ASSESSMENT REPORT

Shoalhaven Starches Expansion Project Installation of Dried Distillers Grain Pelletising Plant Section 75W Modification - MP 06_0228 MOD 4

Figure 3 – Typical elevations of existing and proposed structures

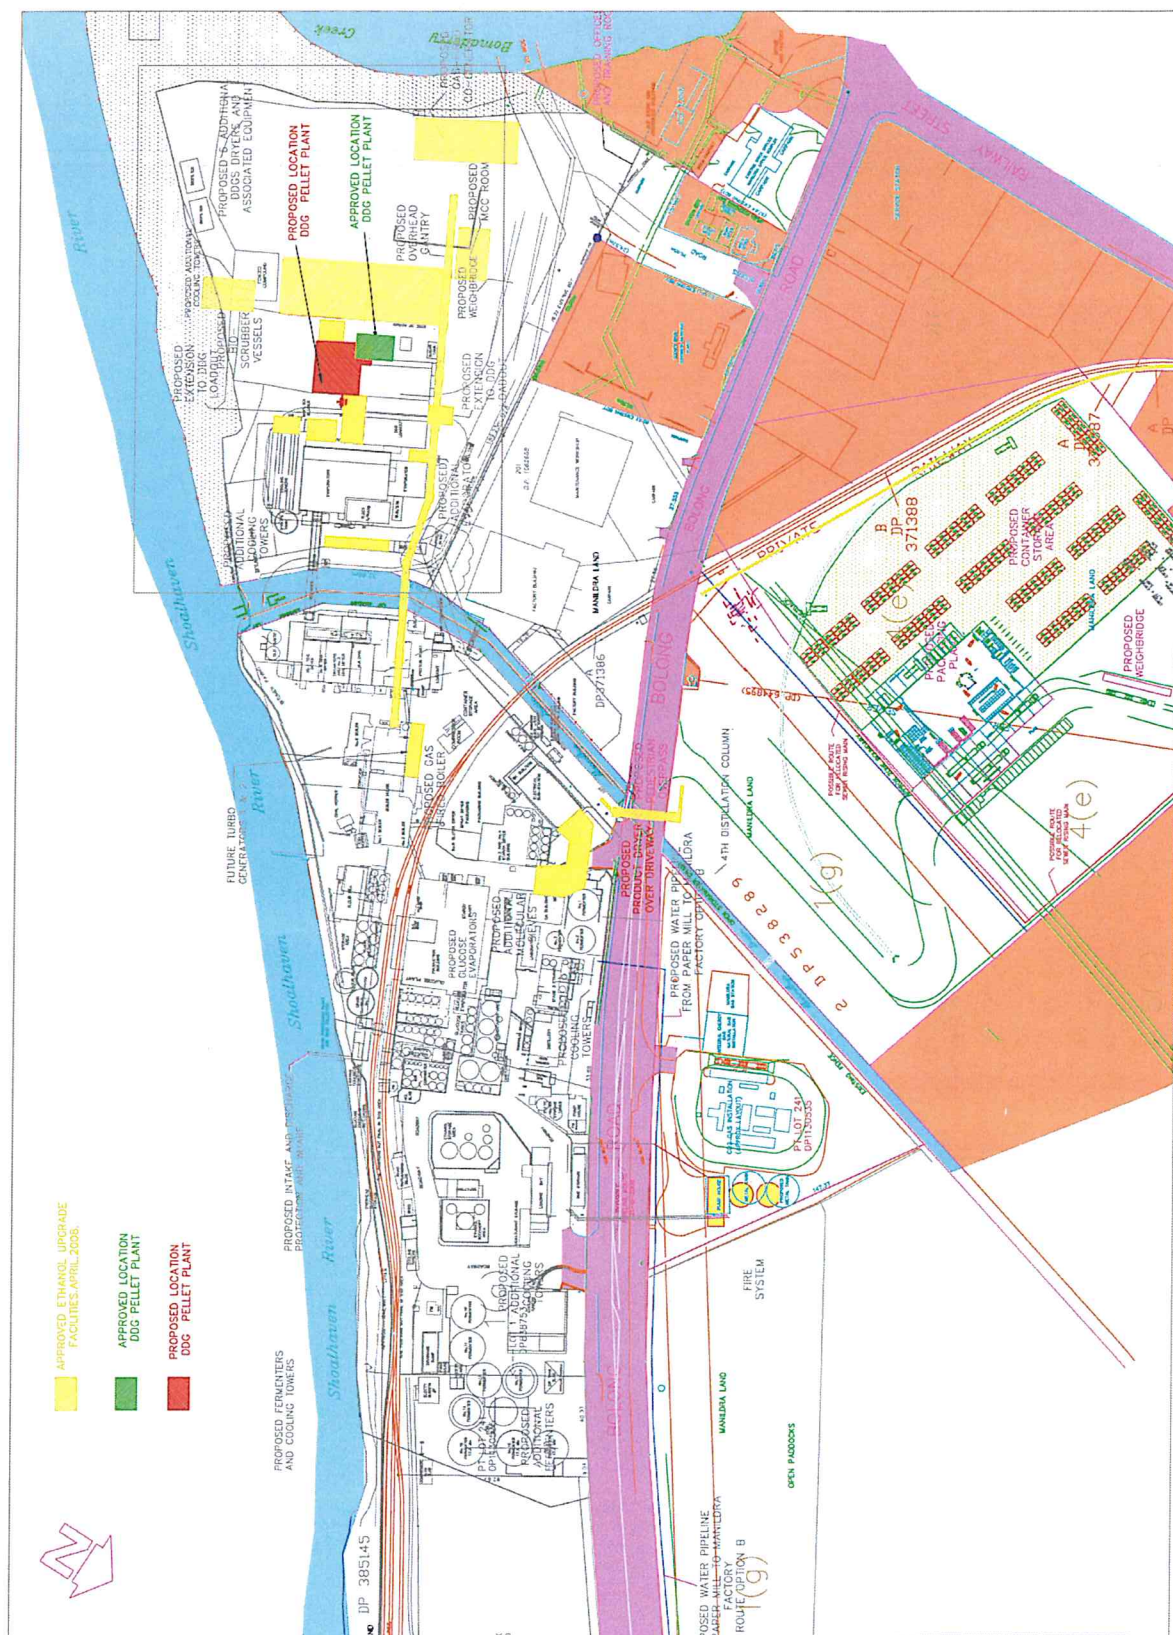
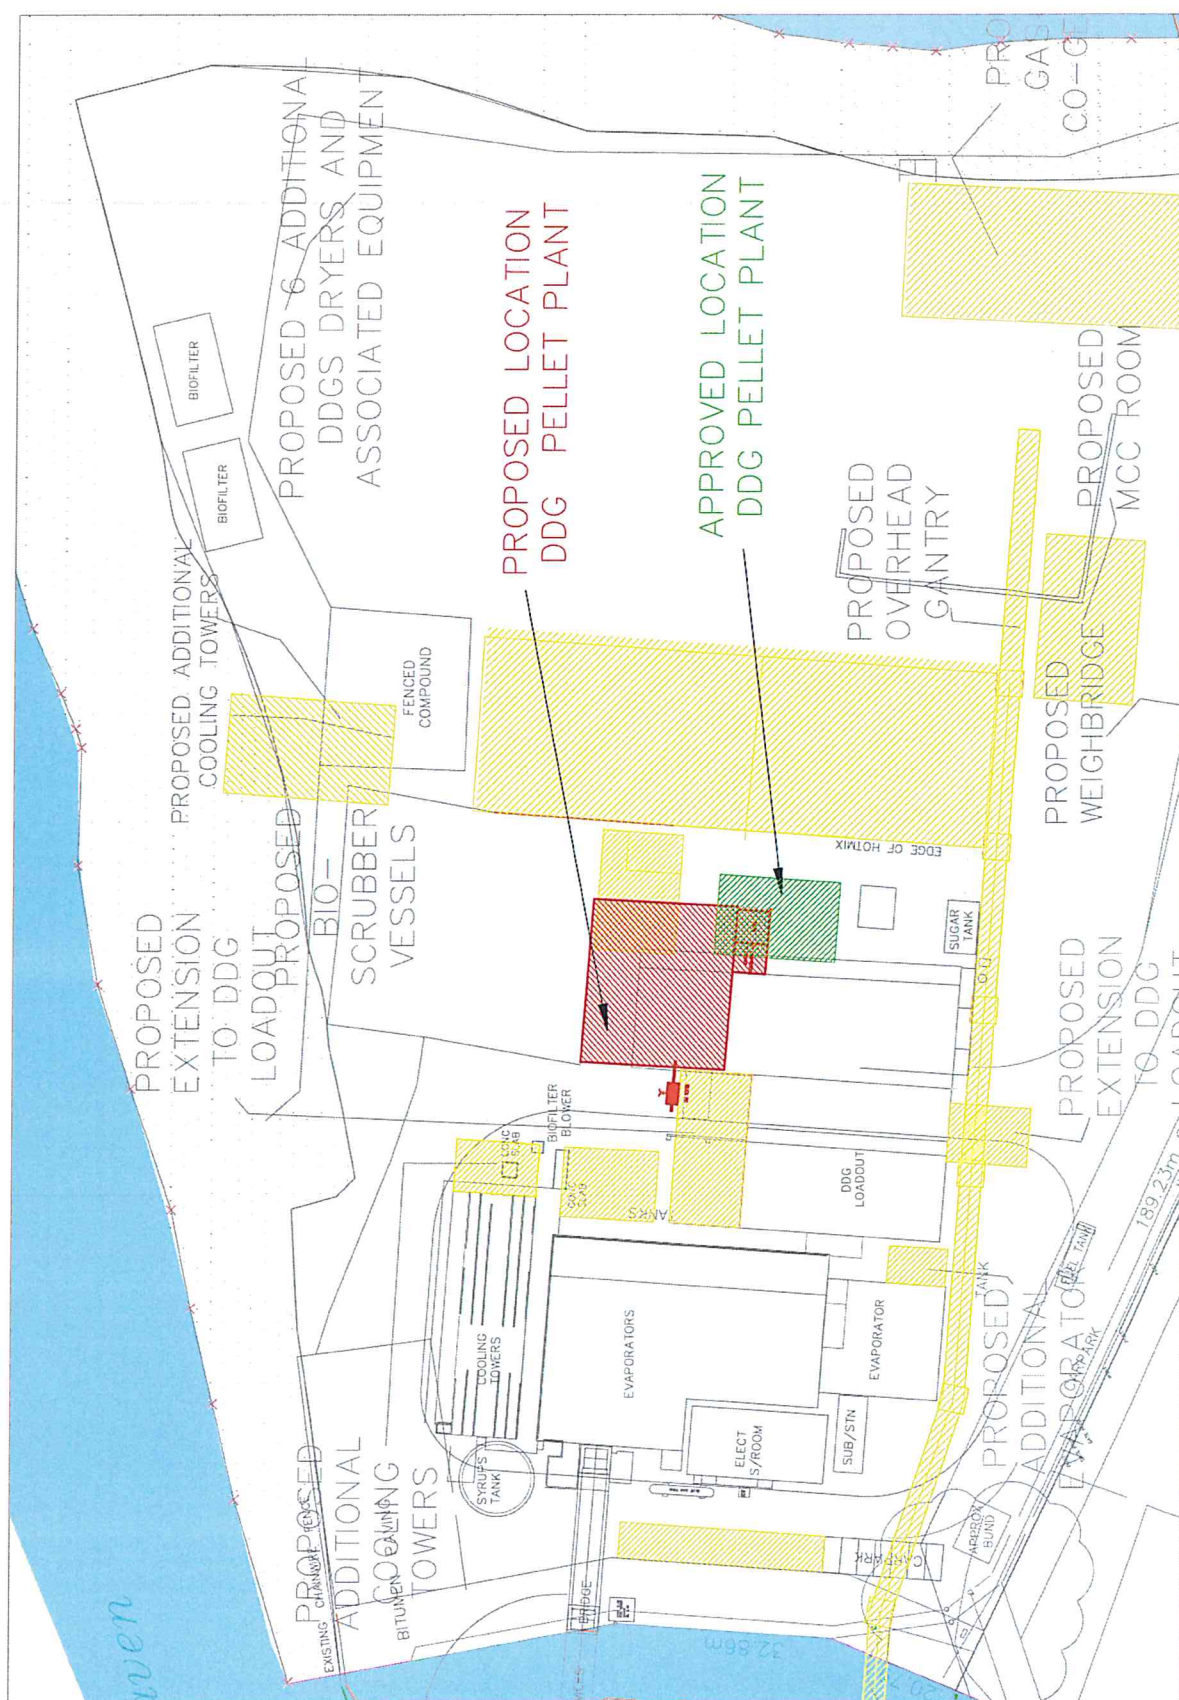
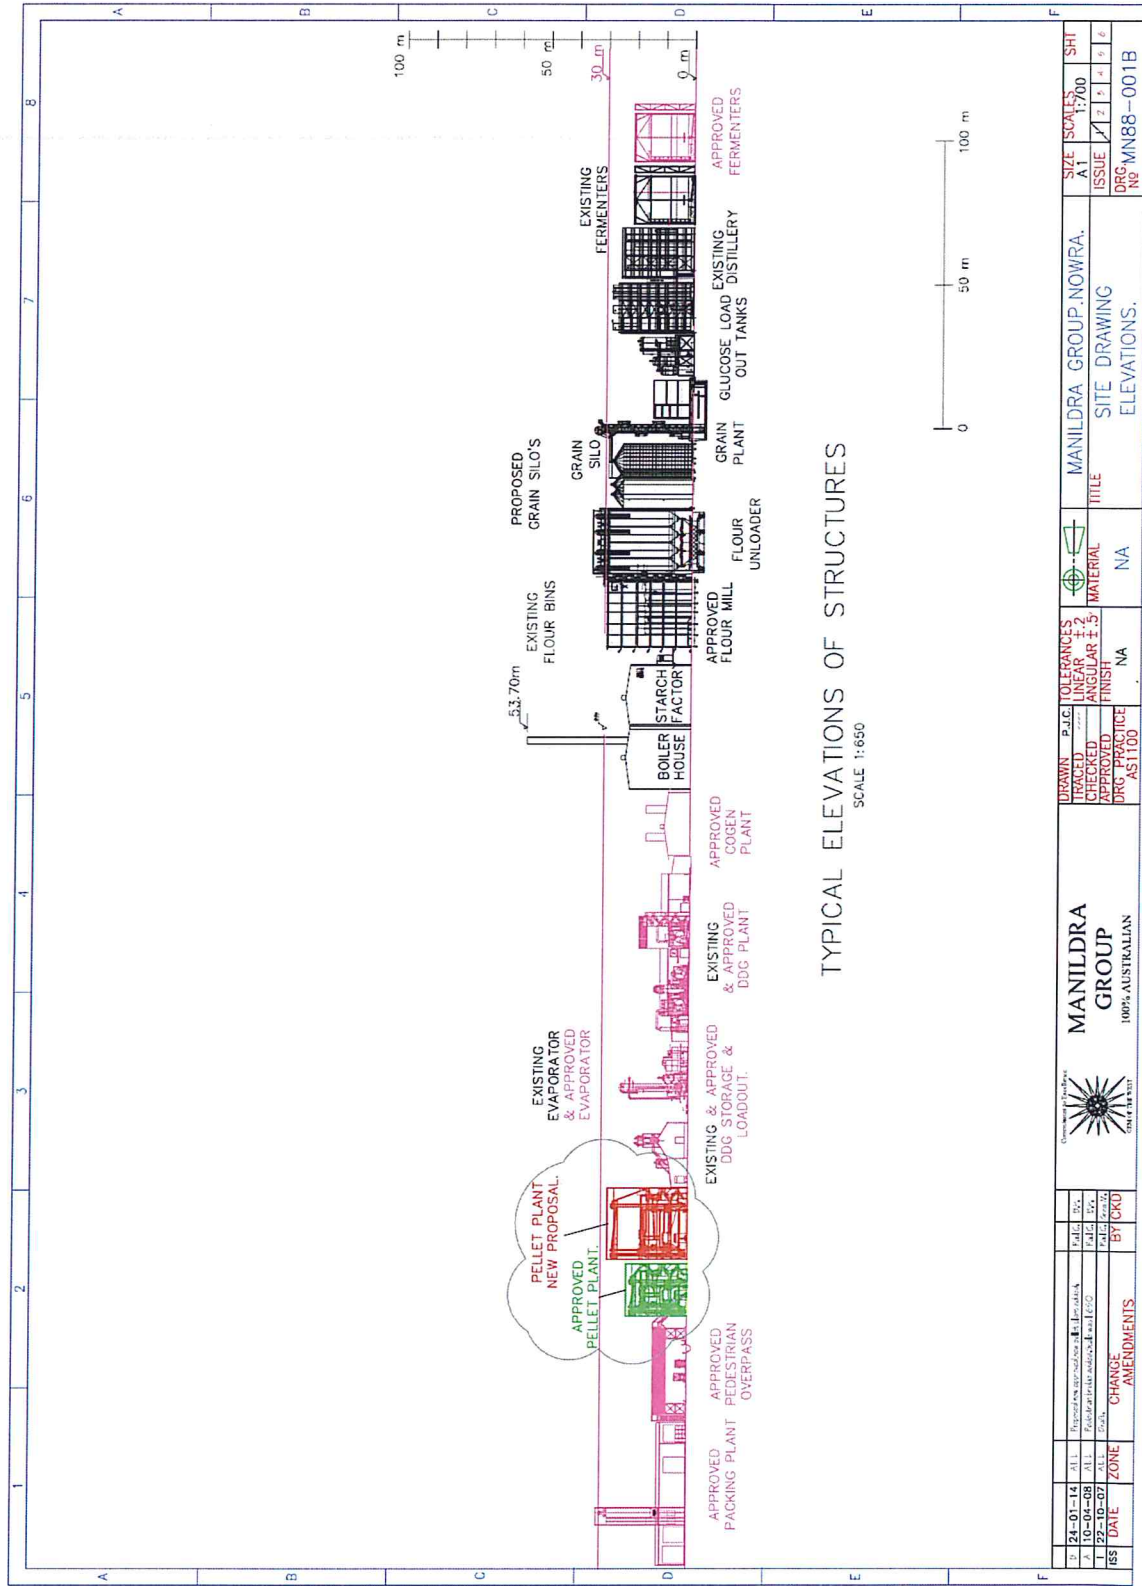
Issue	Assessment	Recommendation
Visual Amenity	<ul style="list-style-type: none"> • The proposed modification would increase the height of the approved DDGS Pelletising Plant by 6.4m from 21.6m to 28m and increase the approved footprint by 375.5m² from 224.5m² to 600m². • The factory is exposed to intermittent viewing from persons in vehicles and pedestrians travelling along Bolong Road, surrounding industrial sites (many owned by Starches) and adjoining rural farmland. • The site is 12.5 hectares in size and the factory partially visible from the nearest residences in Meroo Street, approximately 200m to 500m to the north-east and the village of Terara, approximately 1.5 kilometres (km) to the south on the southern bank of the Shoalhaven River. • The Proponent considers the visual impacts of the proposed modification would be minimal given the scale of the existing industrial development on site and that the additional structures would generally be of a similar appearance, height and bulk to the existing structures on site. • Views to the modified DDGS Pelletising Plant from Bolong Road are likely to be predominantly shielded by existing buildings on site (e.g. maintenance and factory buildings to the north and the adjacent DDGS load out extension). • The maximum height of the DDGS Pelletising Plant at 28m 	<ul style="list-style-type: none"> • Manage through existing conditions of approval.

<p>would also be similar in height to tall components of the existing Distillery.</p> <ul style="list-style-type: none"> • Further, the agency considers the DDGS Pelletising Plant is unlikely to be visible from the nearest residences given the location of existing mature vegetation and existing and approved buildings located between the Starches site and these properties. • Council did not object to the proposed modification and noted that the DDGS Pelletising Plant would be in keeping with the industrial character of that section of Bolong Road and the frontage of the Shoalhaven River. Council also considered that the modified DDGS Pelletising Plant would not be unduly intrusive when viewed from the surrounding locations at Nowra, Terara, Bomaderry and the Bolong Road rural area. • The agency concurs with the views of Council and Proponent and is satisfied that the visual impacts of the proposed modification would be negligible.
